Video Products Technical Bulletin 30-2002-115

SUBJECT: **SHIFT OF VERTICAL HOLD**

MODEL: **SSM-724AMR**

SERIAL NO: **414,165-414,244**

Figure 1

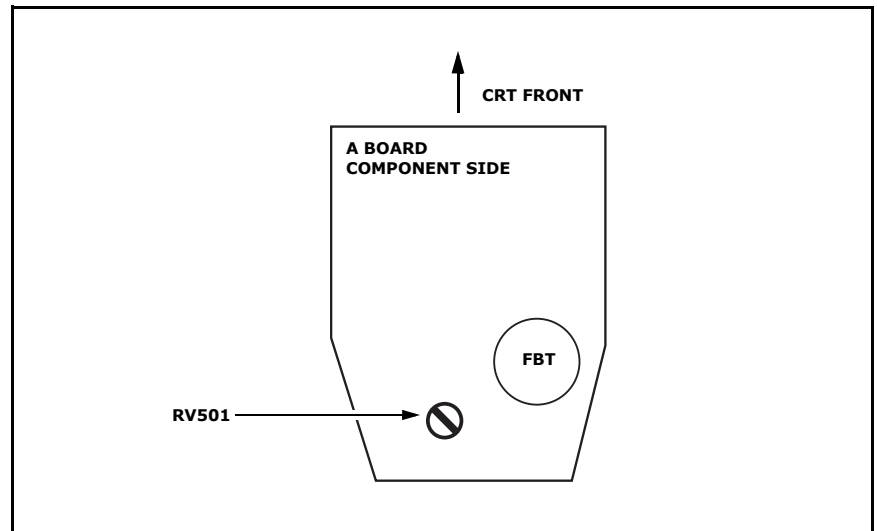
To correct a picture roll (unlocked vertical synchronization), perform the following modification procedure.

1. Open the cabinet.
2. Feed a CCIR (625) signal.
3. On the A Board, Side A (See Figure 1), adjust RV501 (V HOLD) until the picture is steady.

4. Continuing to adjust RV501, find the range in which the vertical hold is steady, and set RV501 to the center of this range.
5. Close the cabinet.
